UNITED STATES PATENT AND TRADEMARK OFFICE

APPLICATION NO.	FILING DATE	FIRST NAMED INVENTOR	ATTORNEY DOCKET NO.	CONFIRMATION NO.
10/797,441	03/09/2004	Michael Harty	D-1222 R2	4488
28995	7590	03/08/2007		
RALPH E. JOCKE walker & jocke LPA 231 SOUTH BROADWAY MEDINA, OH 44256			EXAMINER MCCLAIN, GERALD	
			ART UNIT	PAPER NUMBER
			3653	
SHORTENED STATUTORY PERIOD OF RESPONSE		MAIL DATE	DELIVERY MODE	
3 MONTHS		03/08/2007	PAPER

Office Action Summary

DETAILED ACTION

FIG. G1

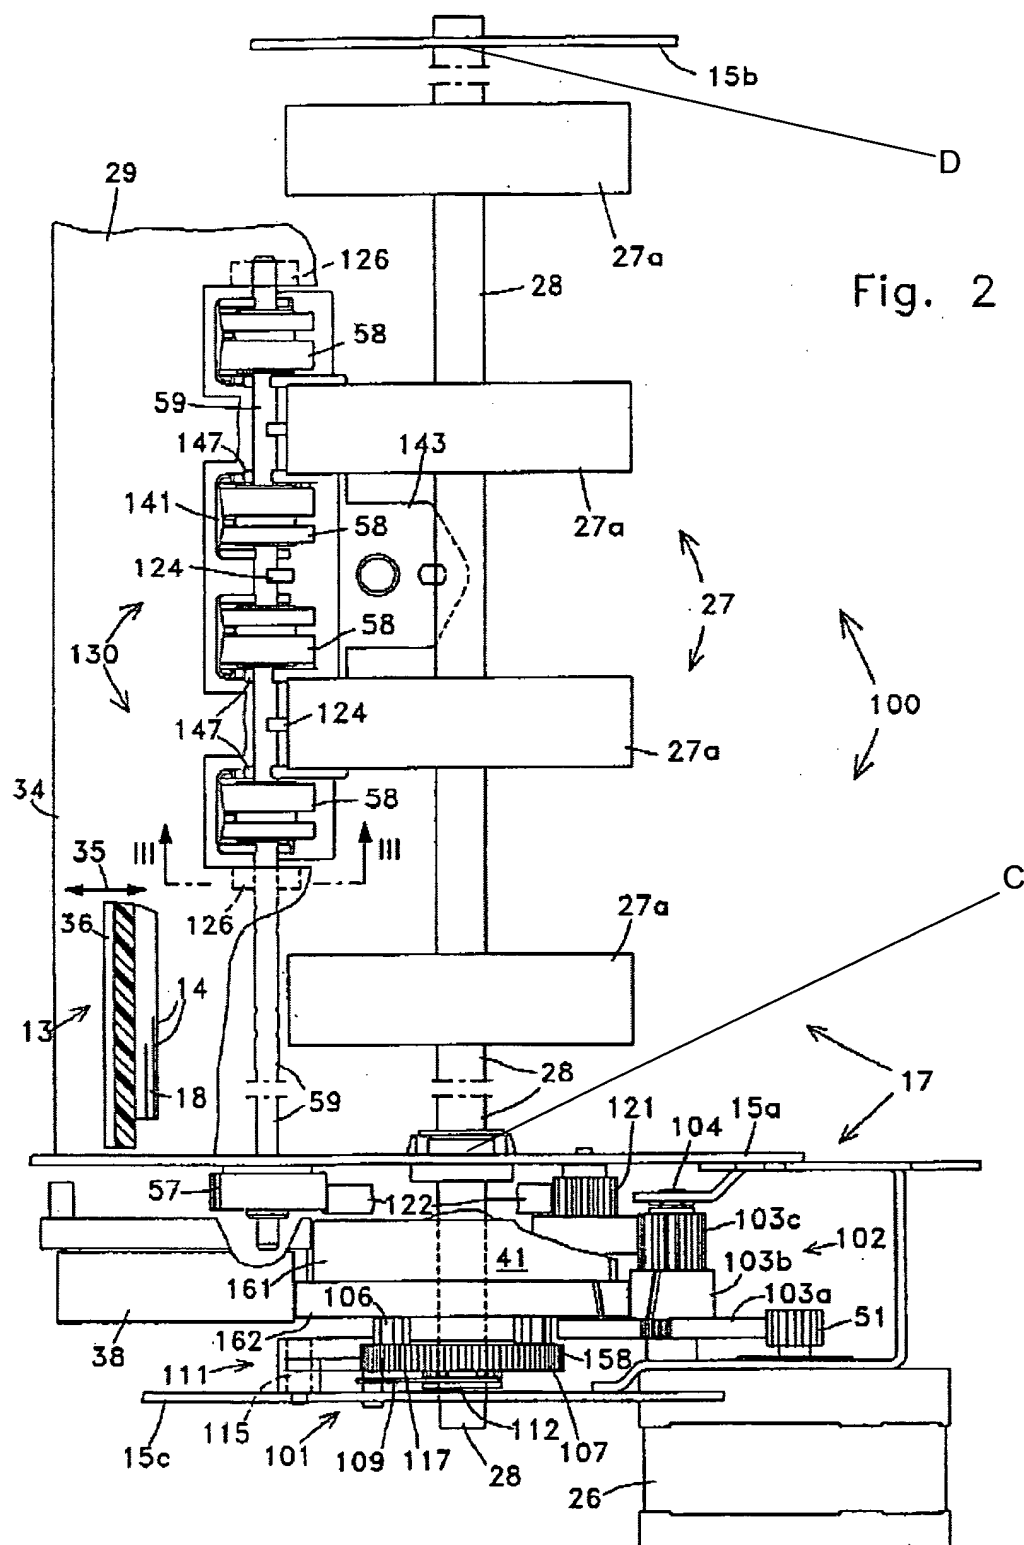
Claim 1: picker arrangement (100); automated banking machine media dispenser (column 1, lines 6-11); rotatable picker shaft (28); drive pin (110); picker roller (27); currency cassette (13); drive end (See Fig. 2, bottom end of 28); mating portion (See FIG. G1 below, C); opposite end (See FIG. G1 below, D); supporting member (15b);
